Access Compliance Report

Public Rights-of-Way

Intersection ID: 16290	Main Street: ELDER_AV	Cross Street: RICHLAND_DR	Location: E
ADA ID: ADDCE359C244	Ramp Type: BlendTrans1	Initial Pass/Fail: Fail	Overall Compliance: No
		Severity Score: 36.25

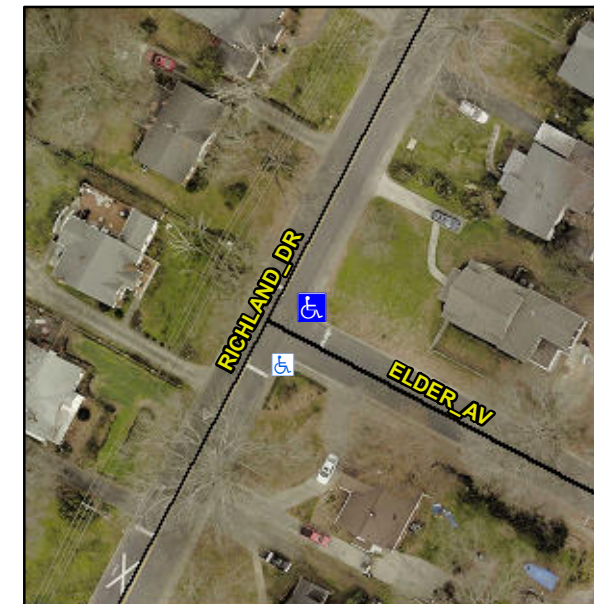
NO RT SW

Not Found, R304.5.1, R304.5.3

Compliance	Description	Data	Compliance	Description	Data
N/A	Ramp Length (in)	60.5	Yes	BlendTrans Slope (%)	1.6
No	Ramp Width (in)	29.0	No	BlendTrans XSlope (%)	3.1
N/A	Flare Type LT	N/A	N/A	Flare Type RT	N/A
N/A	Flare Slope LT (%)	N/A	N/A	Flare Slope RT (%)	N/A
N/A	Flare Traversable LT?	N/A	N/A	Flare Traversable RT?	N/A
N/A	Landing Length (in)	N/A	N/A	DWS Provided?	N/A
N/A	Landing Width (in)	N/A	N/A	DWS Contrast?	N/A
N/A	Landing Slope (%)	N/A	N/A	DWS Length (in)	N/A
N/A	Landing X Slope (%)	N/A	N/A	DWS Full Width?	N/A
N/A	Landing Curb? (Y/N)	N/A	N/A	DWS Offset (in)	N/A
N/A	Shared Landing?	N/A			
N/A	Gutter Ponding?	N/A	N/A	Gutter Slope (%)	N/A
N/A	Gutter Lip Ht (in)	N/A	N/A	Gutter X Slope (%)	N/A
N/A	Painted X Walk1?	No	N/A	Painted X Walk2?	N/A
	X Walk 1 Direction	To SW		X Walk 2 Direction	N/A
	X Walk 1 Width (in)	N/A		X Walk 2 Width (in)	N/A
	X Walk 1 Slope (%)	0.7		X Walk 2 Slope (%)	N/A
	X Walk 1 X Slope (%)	5.3		X Walk 2 X Slope (%)	N/A

N/A	Ramp inside XWalk1?	N/A	N/A	Ramp inside XWalk2?	N/A
	Road Slope (%)	5.3		Clear Space?	N/A
	Road X Slope (%)	0.7	N/A	Clear Space to XWalk (in)	N/A
N/A	Any Obstructions?	N/A	N/A	Storm Grate/Utility Hazard?	N/A
	Obstruction Type			Storm Grate/Utility Type	
		N/A			N/A
			Yes	Surface Condition? (G/P)	Good
			No	Curb Slope (%)	7.7

Remove & Replace Curb Ramp With Two New Directional Ramps or Equivalent.
